Town of Amherst  
Planning Advisory Committee Meeting  
Agenda

**TO:** Planning Advisory Committee

WHEREAS the Owner wishes to obtain permission pursuant to Policy RP-9 of the Municipal Planning Strategy of the Town of Amherst, to construct three 54-unit apartment dwellings on property located at Lot 2021-2R Walter Purdy Avenue (PID 25002122).

TITLE:  
SITE PLAN

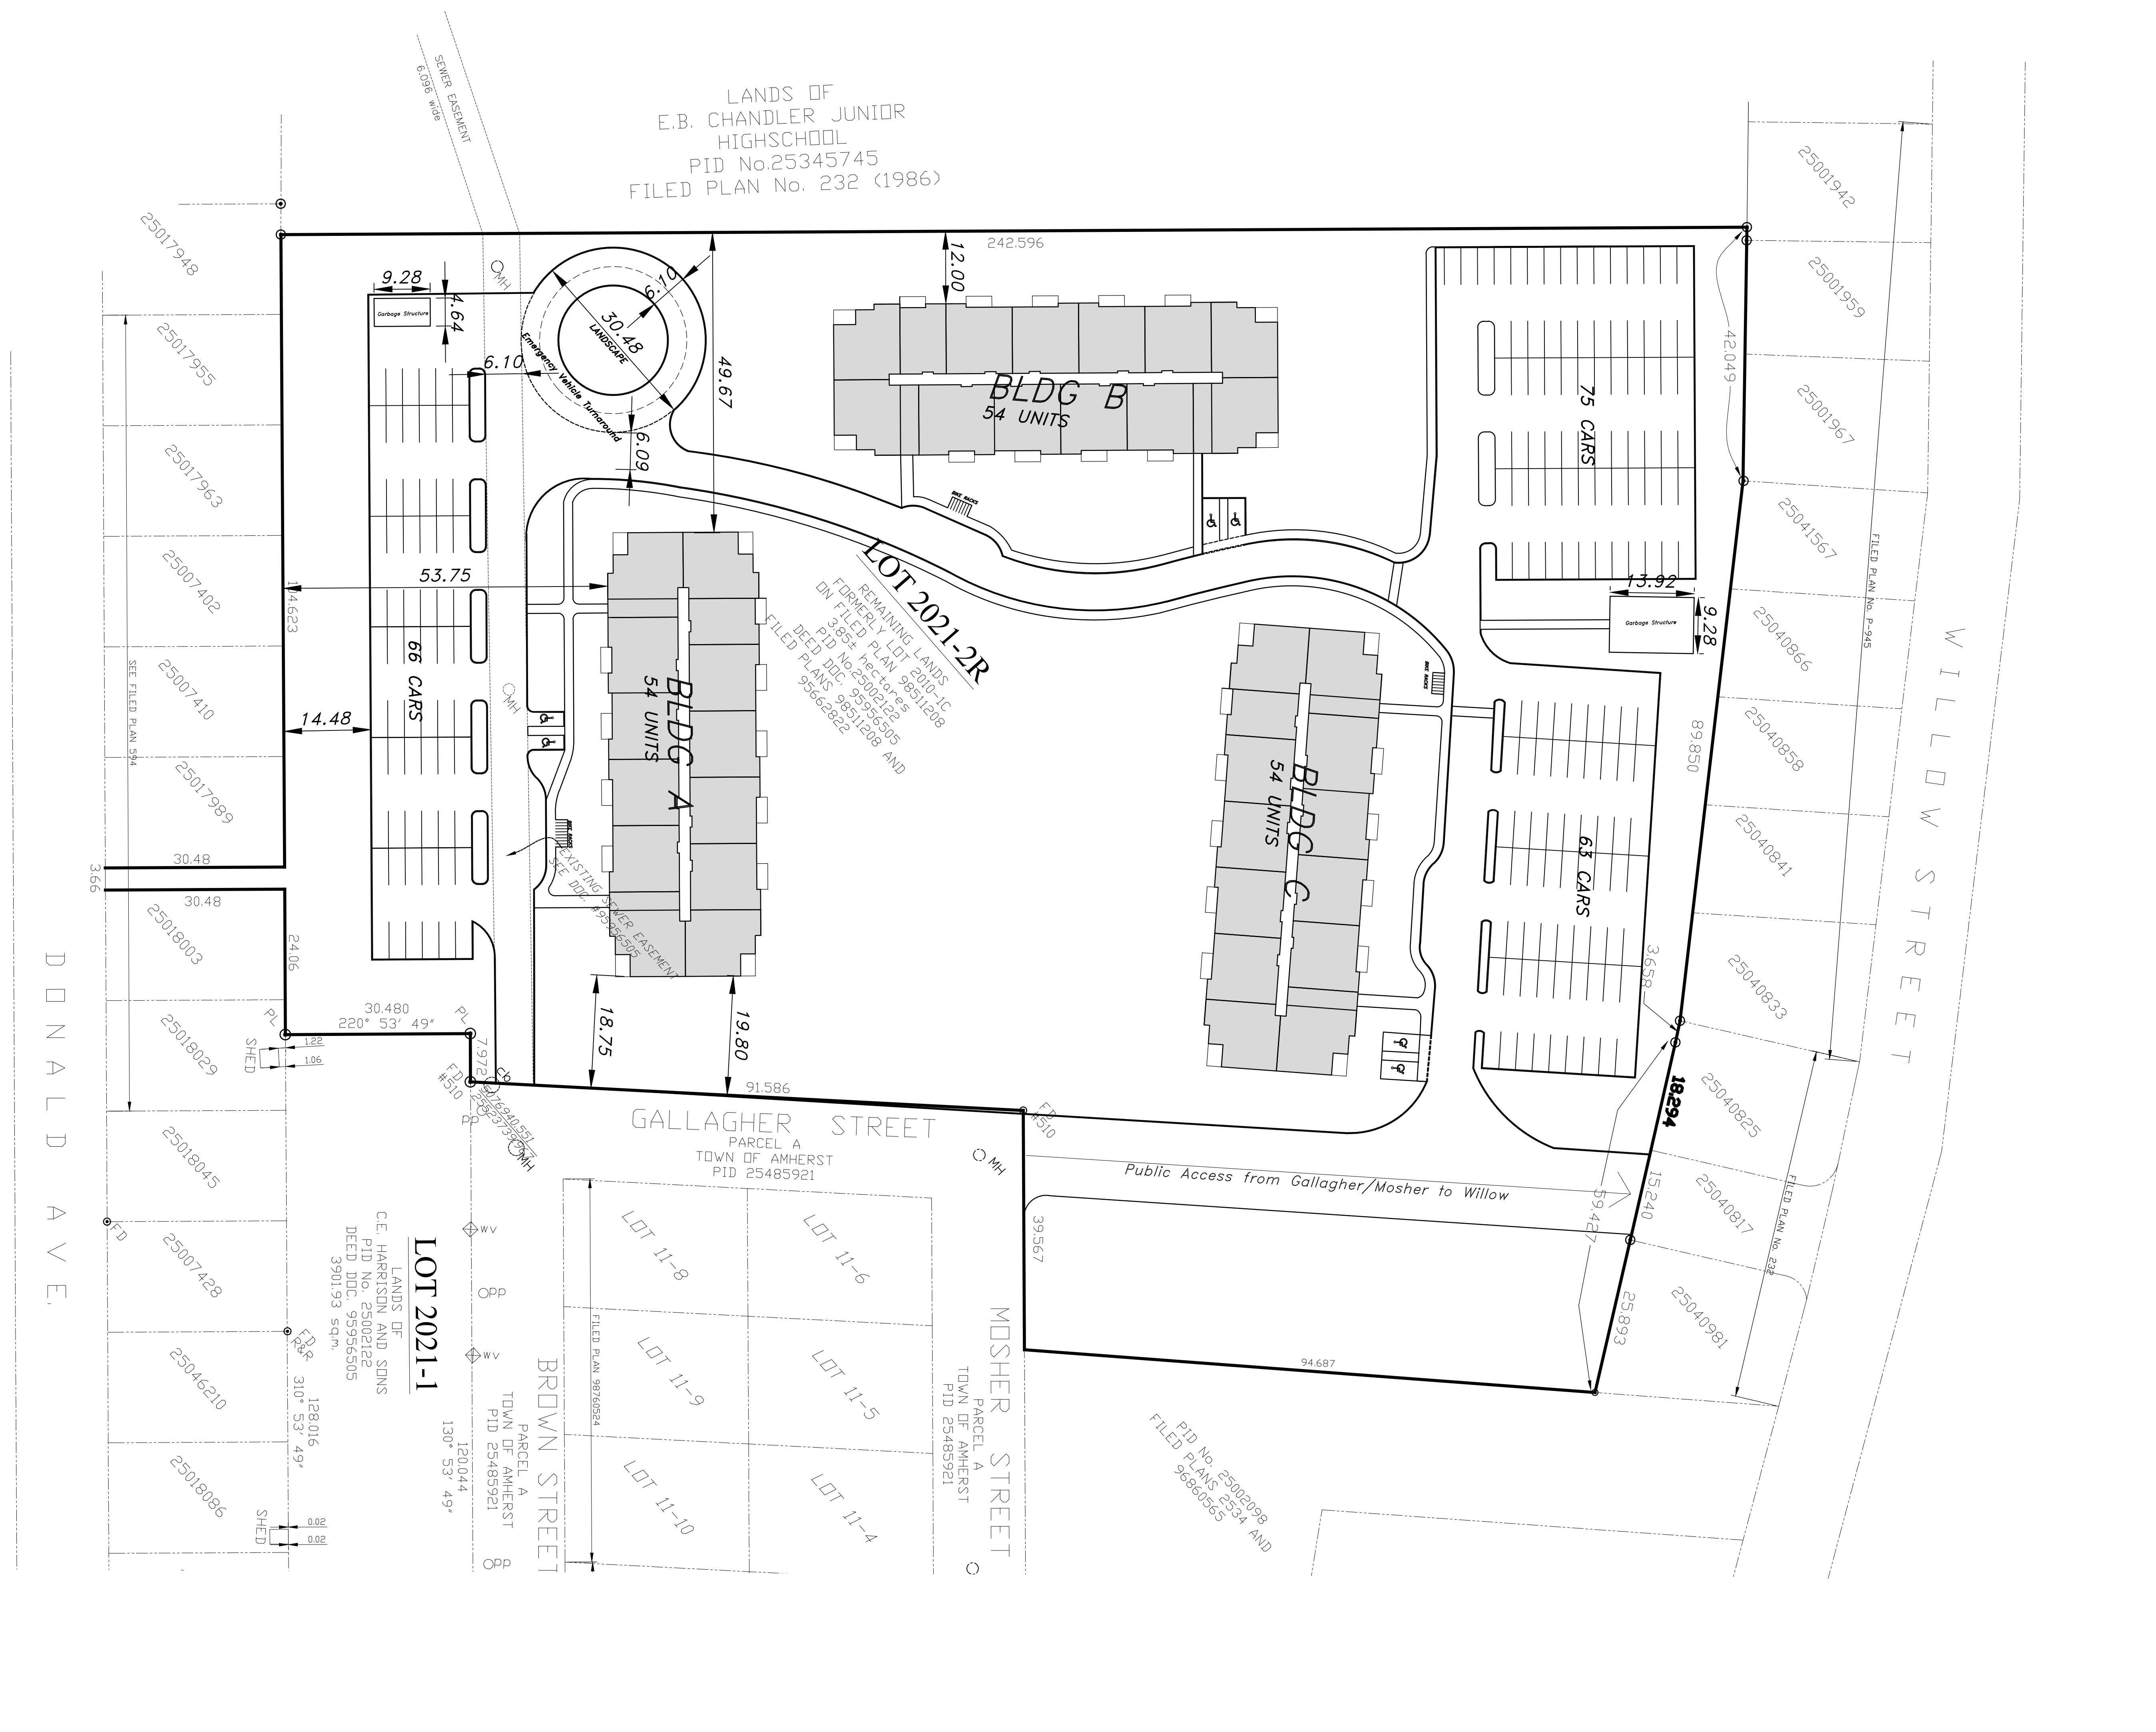
2. Perspective View –provide perspective views of the proposed buildings and existing adjacent structures.
  - Perspective views of the three buildings is attached to this report.
3. Building C – concerns were raised about the closer proximity of this building to adjacent properties along Willow Street.

Staff Comment: changing the position of Building C increases the setback to approximately 50 m (164 ft) to the rear property line of the nearest dwelling on Willow Street.

- Additional parking spaces to meet the LUB 1.25 spaces/unit standard have been provided in the revised site plan.

Staff Comment: The development now meets the LUB standard and is configured such that a shortage of parking is unlikely to impact the surrounding neighborhood due to the distance to the proposed buildings. The development agreement will contain a requirement that any additional parking shall not be located closer to adjacent properties.

# SCHEDULE "C"

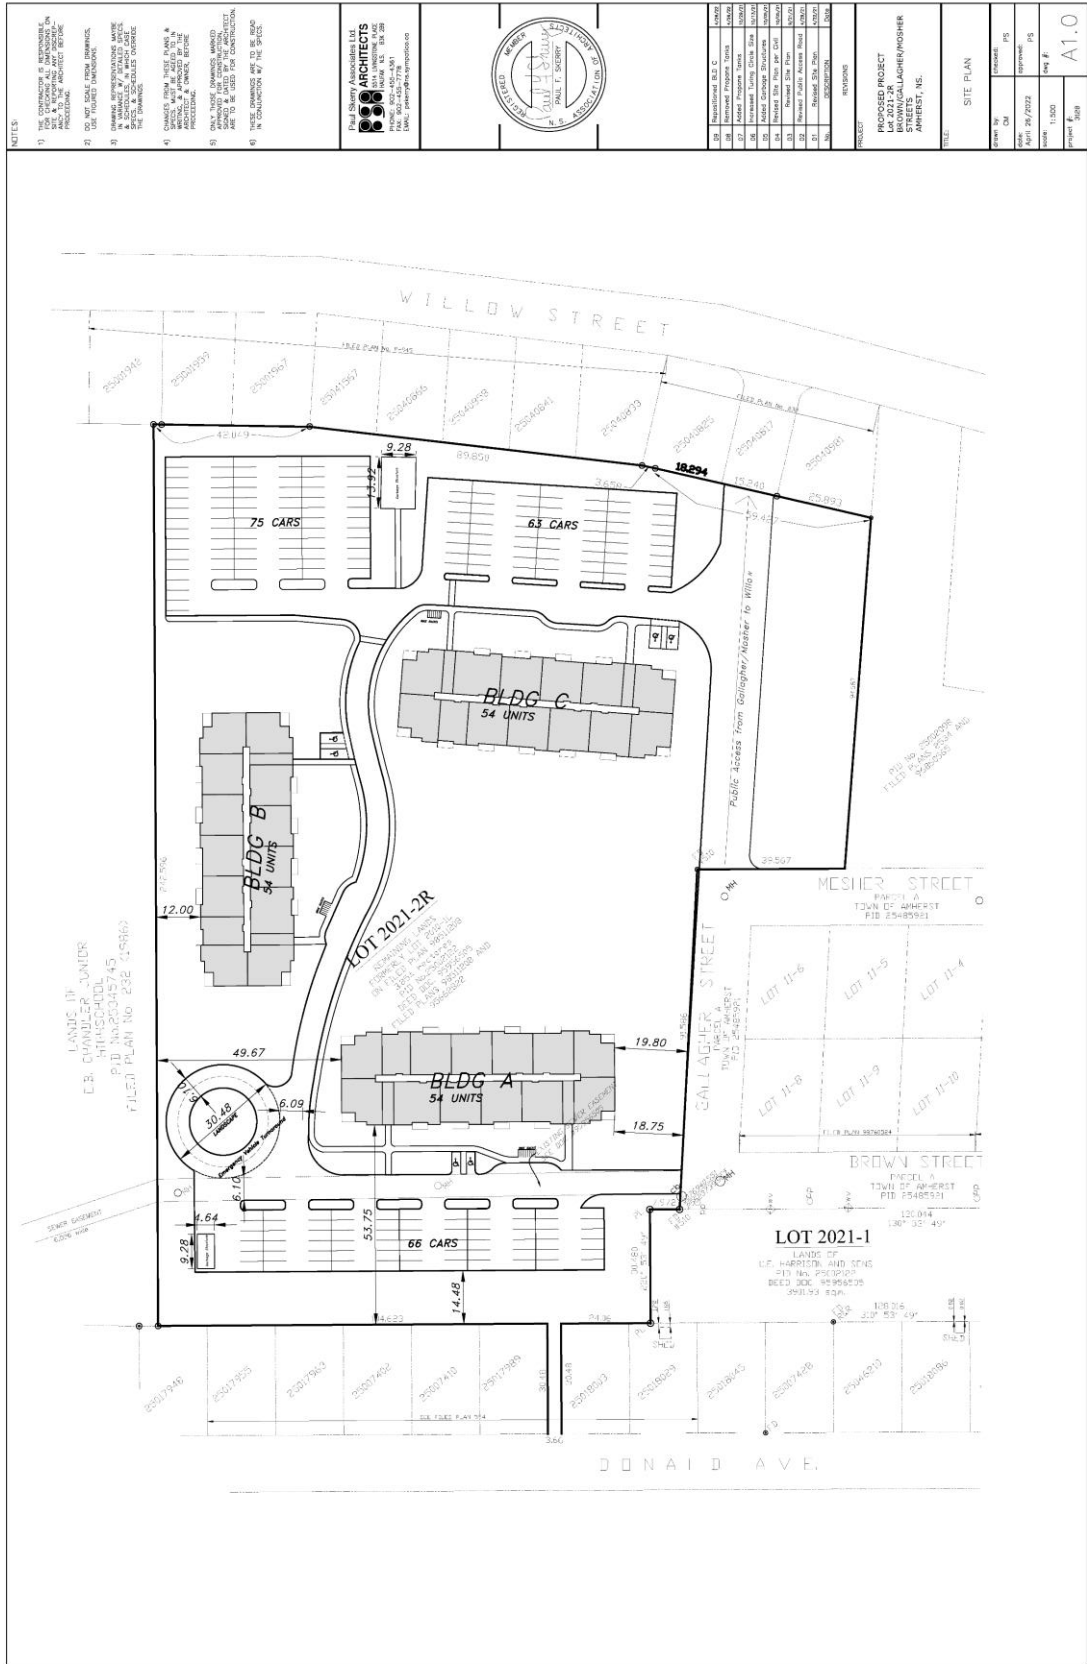
6. Landscaping Plans – request to provide more information regarding landscaping of the site and the use of vegetation and/or visual barriers to provide buffering to adjacent residential properties. Perhaps the use of opaque fencing could be used.

- A landscaping plan is attached to this report.

Staff Comment: The development agreement will require submission of a detailed Landscaping Plan, generally as shown on the Landscape Concept Plan. In particular, the developer shall erect fencing at least 6 feet in height as shown on the western side of the Landscape Concept Plan
